Access Compliance Report

Public Rights-of-Way

| Intersection ID: 54217 | Main Street: GOLF_LINKS_DR | Cross Street: MIDWAY_PARK_DR | Location: NE |
| ADA ID: F2C84C3F6537 | Ramp Type: Perp | Initial Pass/Fail: Fail | Overall Compliance: No |

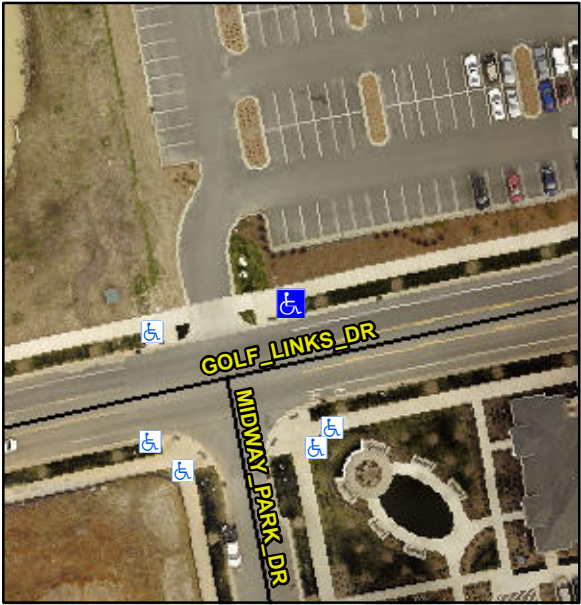
| Codes/Mitigation Info/Possible Solution | | Field Measurements/Component Compliance | | | | | |
|--|-------------------------------|---|-----------------------|------|-----|-----------------------------|------|
| | Remove & Replace Entire Ramp. | N/A | Ramp Length (in) | 94.0 | No | Ramp Slope (%) | 9.8 |
| | | Yes | Ramp Width (in) | 61.0 | No | Ramp XSlope (%) | 2.5 |
| <p>Surveyor Notes:</p> <p>N/A</p> <p>PROW/ADA:</p> <p>R304.2.2, R304.5.3</p> | | N/A | Landing Curb? (Y/N) | N/A | N/A | DWS Offset (in) | N/A |
